Adjacent SIGNAL_OK

(follow up on comment #356 against D1.3)

Adee Ran, Cisco

Case 2: one AUI (2 PMAs)

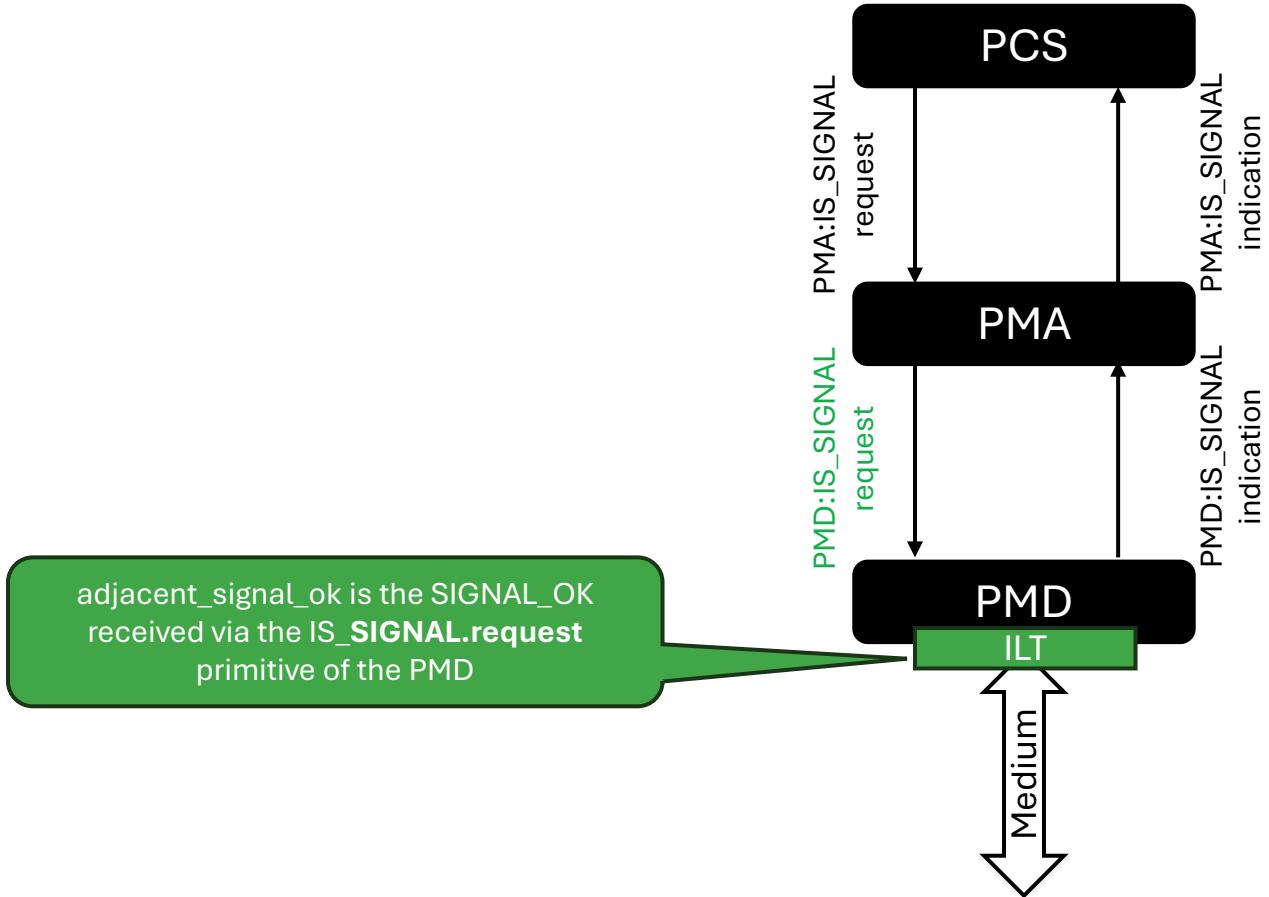
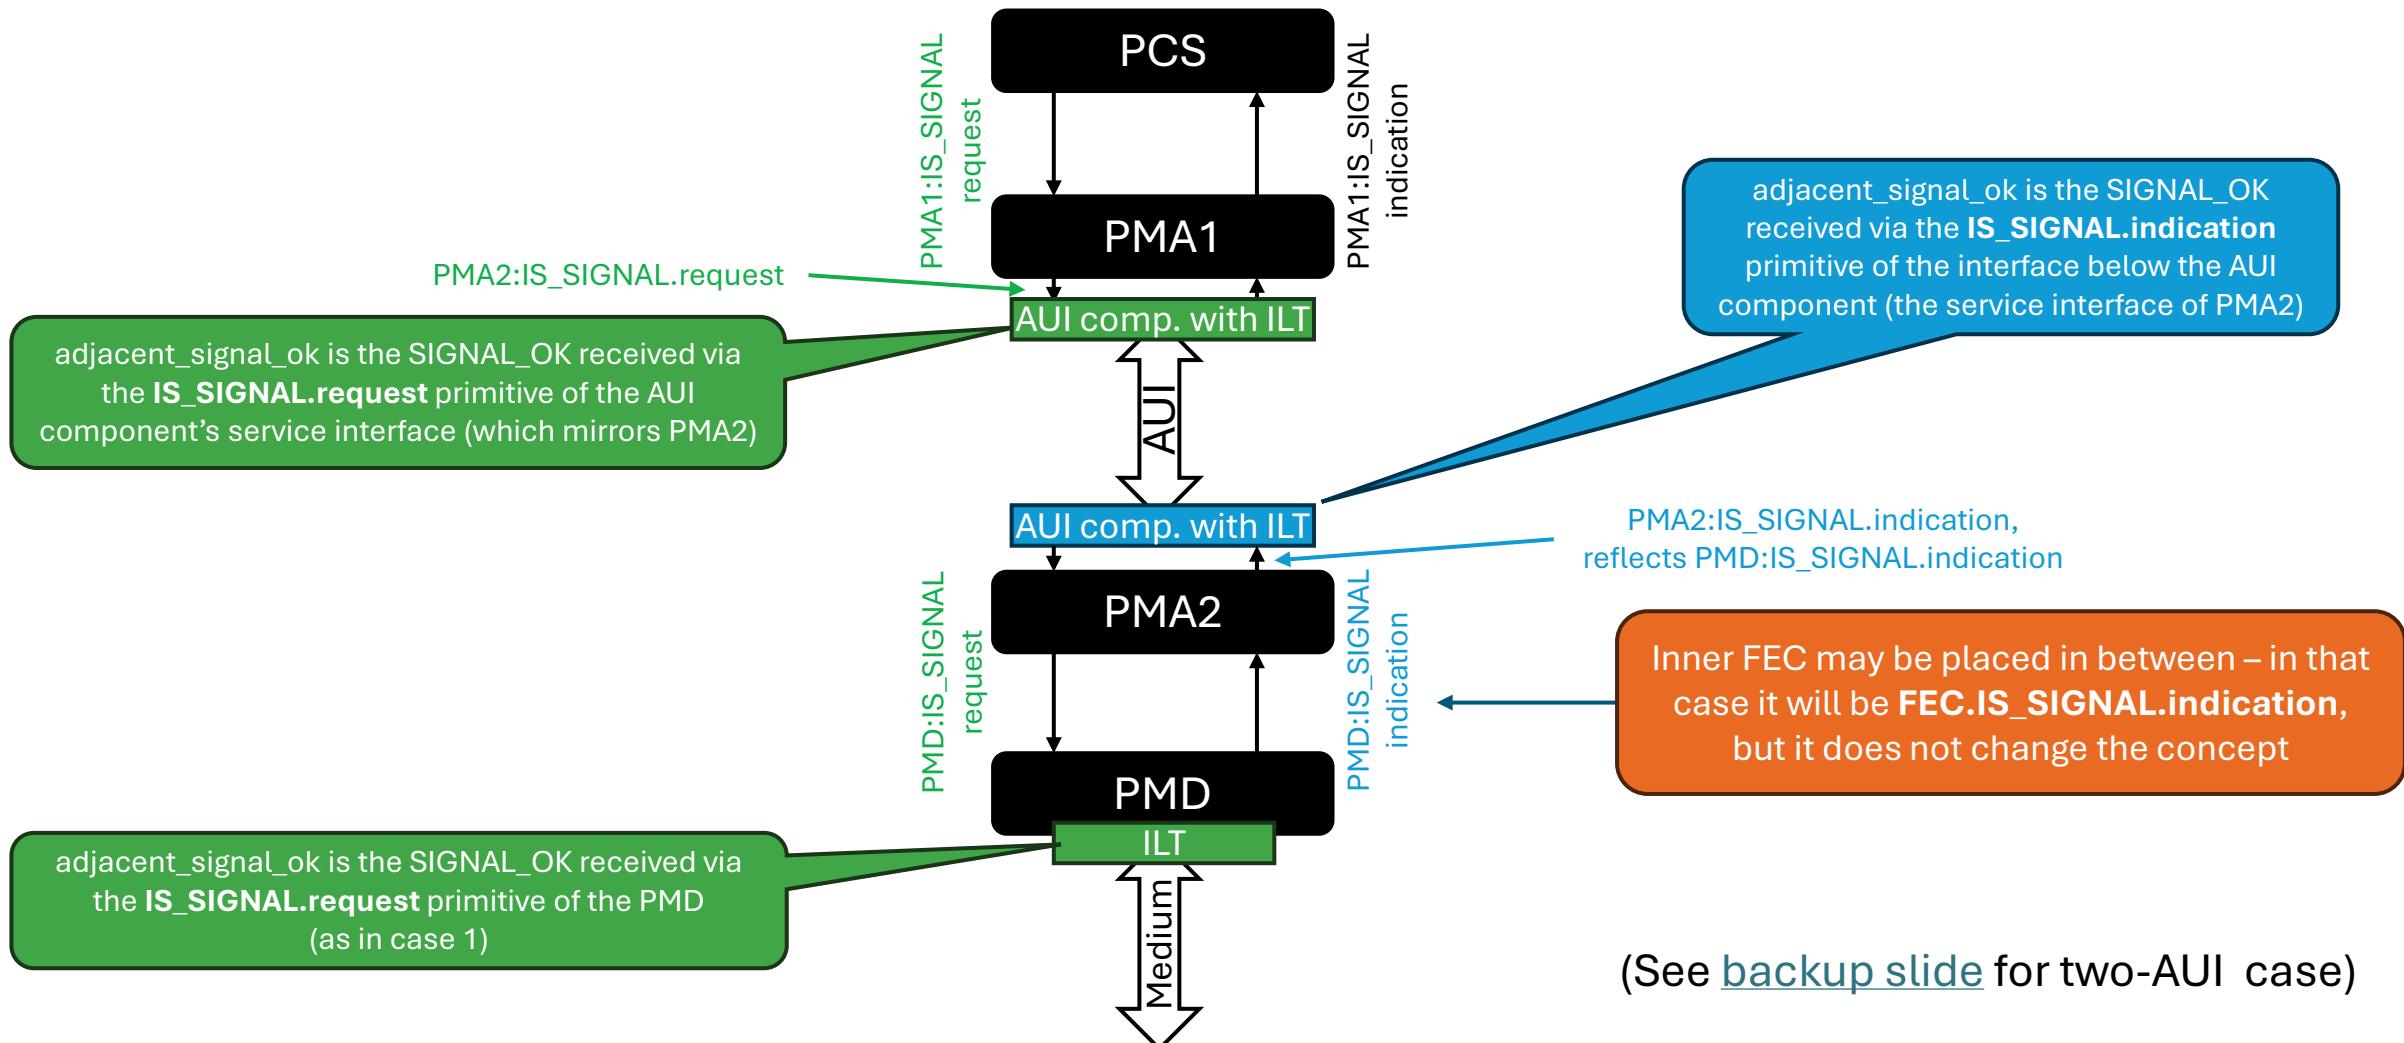
- Define a new variable, **adjacent_signal_ok**, which will be used to derive both **adjacent_remote_rts** and **adjacent_isl_ready**.
- The new variable is taken from SIGNAL_OK of either IS_SIGNAL.request or IS_SIGNAL.indication, depending on the position of the ILT function:
 - For “**downward**” ILT (in a PMD or AUI component), it is IS_SIGNAL.request of the service interface of the PMD or AUI component.
 - For “**upward**” ILT (only in an AUI component), it is IS_SIGNAL.indication of the interface below the AUI component (the service interface of the PMA below, which eventually reflects the service interface of the PMD).
- This is illustrated in the next slides.

- The figures above show **PMA:IS_SIGNAL.request** primitives beneath the PCS.
- IS_SIGNAL.request is a service interface primitive of the PMD, PMA, and inner FEC sublayers

- The logic for generating it when the client is the PCS (PMA:IS_SIGNAL.request) is not described...
 - But it is simple: the PCS generates FAIL when it does not transmit data (e.g., PCS_reset is true), and OK otherwise.

- This can be understood from the description in 116.3.3.4, without further addition in the PCS clauses.
- However, this primitive is not shown in many service interface diagrams (unlike PMA:IS_SIGNAL.indication).

- It is proposed to add it where it is missing.

Figure 174–2—Inter-sublayer service interfaces for a 1.6TBASE-R PHY

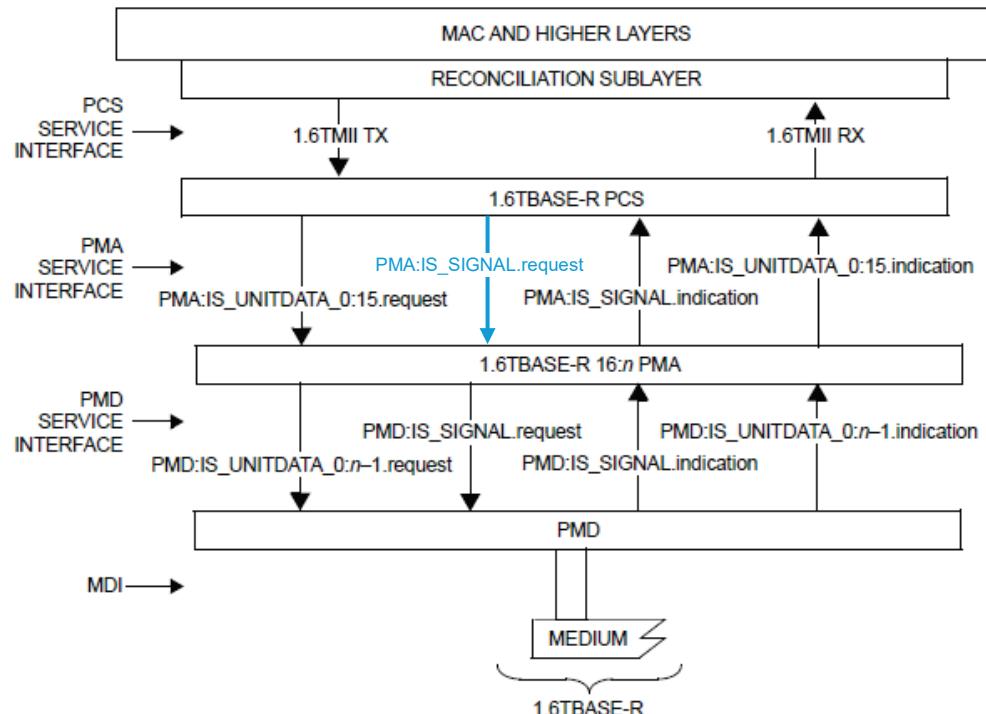
Proposed figure changes

- Similar arrows should be added in all inter-sublayer service interface diagrams:
 - Figure 116–2, Figure 116–2a, Figure 116–3, Figure 116–3a
 - Figure 169–2, Figure 169–2a, Figure 169–3 (twice)
 - Figure 174–2 (shown), Figure 174–3 (twice), Figure 174–4
 - Figure 185–2 (FEC service interface), Figure 185–3 (both PMA and FEC)
- And in functional block diagrams:
 - Figure 119–2 (not in the draft)
 - Figure 172–2
 - Figure 175–2

116.3.3.4 IS_SIGNAL.request

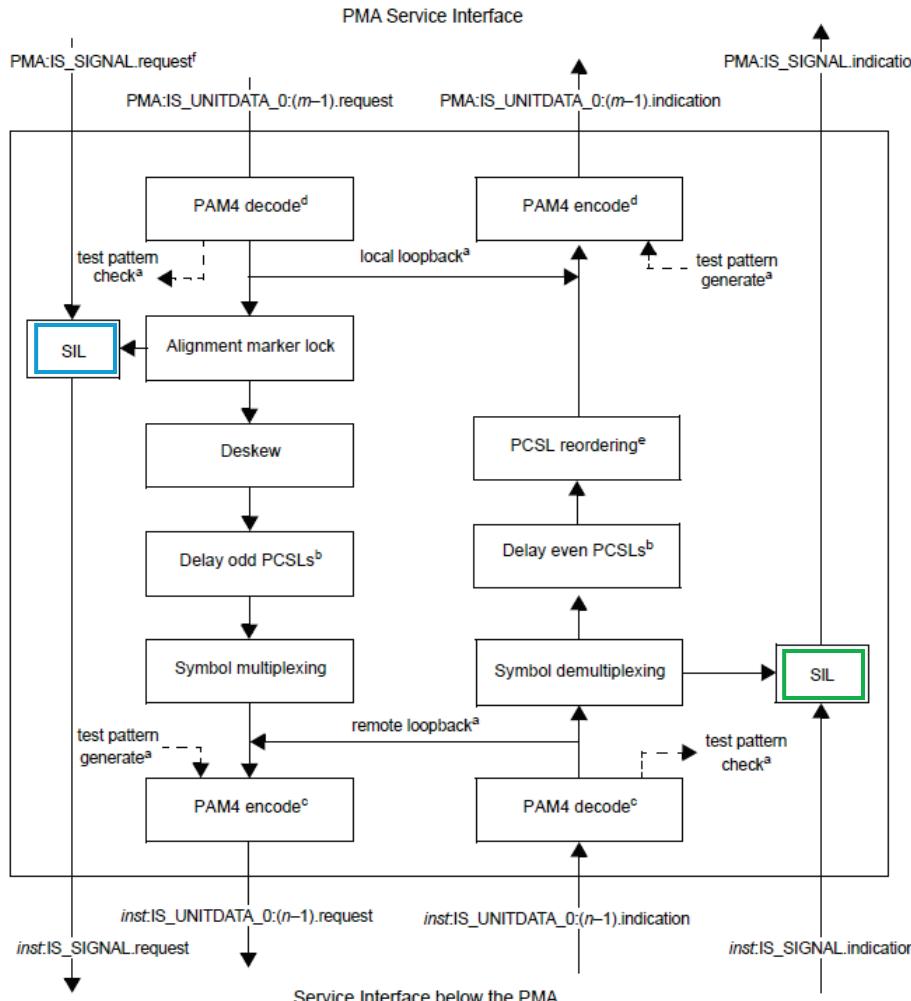
- “**received by the sublayer**” is a mistake – it is in the transmit direction so it should be “transmitted”.
- a comment will be submitted
